Contract #: 04-0120F4Cty: SF/ALA Rte: 80 PM: 13.2/13.9File #: 69.25B**QUALITY ASSURANCE -- NON-CONFORMANCE REPORT****Location:** Changxing Island, Shanghai, P. R. China**Report No:** NCR-000481**Prime Contractor:** American Bridge/Fluor Enterprises, a JV**Date:** 16-Oct-2009**Submitting Contractor:** Zhenhua Port Machinery Company, Ltd (ZPMC), Changxing Island**NCR #:** ZPMC-0454**Type of problem:**

| <b>Reference Description:</b> Heat Straightening without Engineer's Approval on Seg 6BW Upper Flange of FB003-045 |                   |  |   |

**Subject:** NCR No. ZPMC-0454

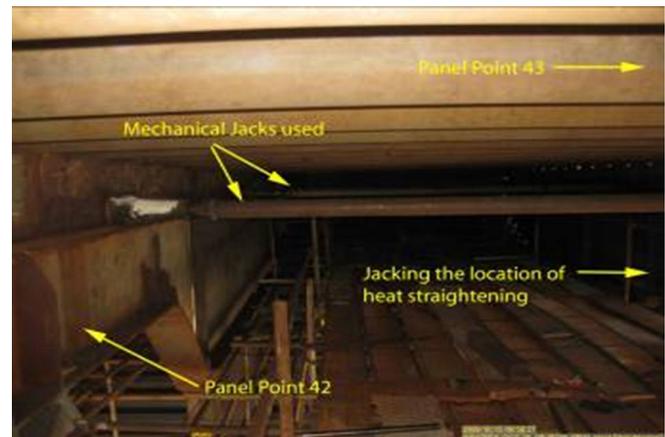
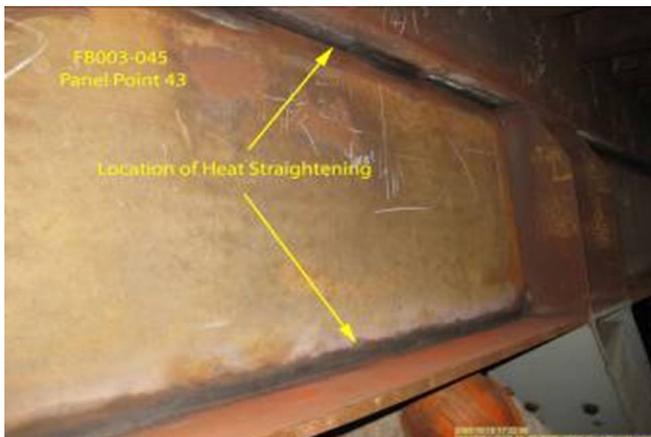
During random visual inspection of OBG Segment 6BW at panel point 43. The Caltrans Quality Assurance (QA) Inspector observed that contractor was Heat Straightening the FL2-1 floor beam FB003-045 of the upper flange X6F at panel point 43 by the use of a mechanical jack without the approval of the Engineer. The maximum distortion measurements that were taken at this upper flange is 12mm prior to the Heat Straightening and mechanical jacking.

HSR1(B)-7745

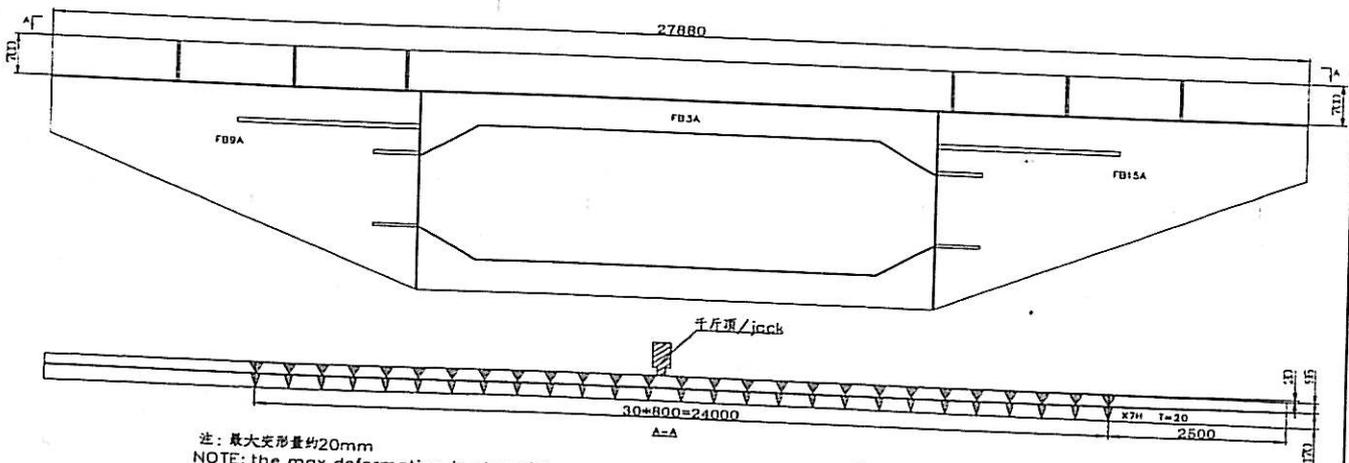
Cause 原因: Welding distortion 焊接变形

Type of Defect 缺陷类型: Welding distortion 焊接变形

后续 NDE (Post-Removal NDE): After finishing heat straightening, the weld of the heat area shall perform NDT according to the approved shop drawing 校火后, 根据图纸要求对热影响区域进行 NDT 检测。

纠正措施 (Corrective Action(s)): Control current, voltage and weld speed according to relevant WPS. If necessary anti-deformation or hold down device can be added. 依据相应的 WPS 的要求控制电流, 电压和焊接速度。如有必要, 可使用反变形设施进行校正。
